## **HART PACIFIC ENGINEERING**

**DATE:** August 13, 2010  
**TO:** All Bid Set Plan Holders  
**RE:** "A" St. to Main Street Stormdrain Phase 1  
Addendum #1

**“A” St. to Main St. Stormdrain Improvement Phase 1  
Addendum #1**

ADDENDUM 1 REVISION SHEET C-2  
CATCH BASIN 6, STA. 4+17.5  
SCALE 1"=3'

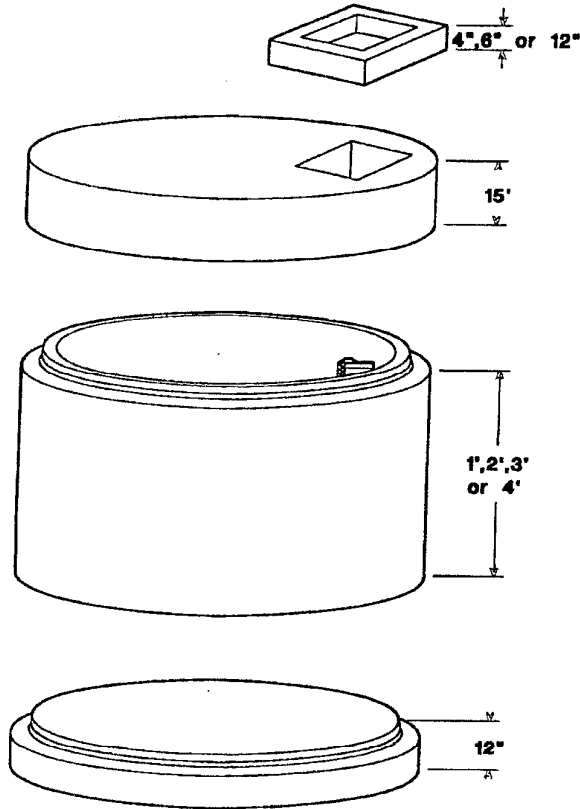
12. Sheet C-2 of the plans, Note 8:  
The existing well shall not be decommissioned. Note 8 is revised as follows:  
"The Contractor is required to preserve and protect the existing well and well house." The location of Catch Basin 6 shall be moved 2.5' west of the location shown on sheet C-2 so that the offset from the construction survey staking to the center of the basin shall be 7.5' instead of 10.0'. The interior angle of the 18" pipe alignments is revised from 169 degrees to 166 degrees. See attached detail of this area for clarification of this change.

7.5' OFFSET (WAS 10.0')

166°
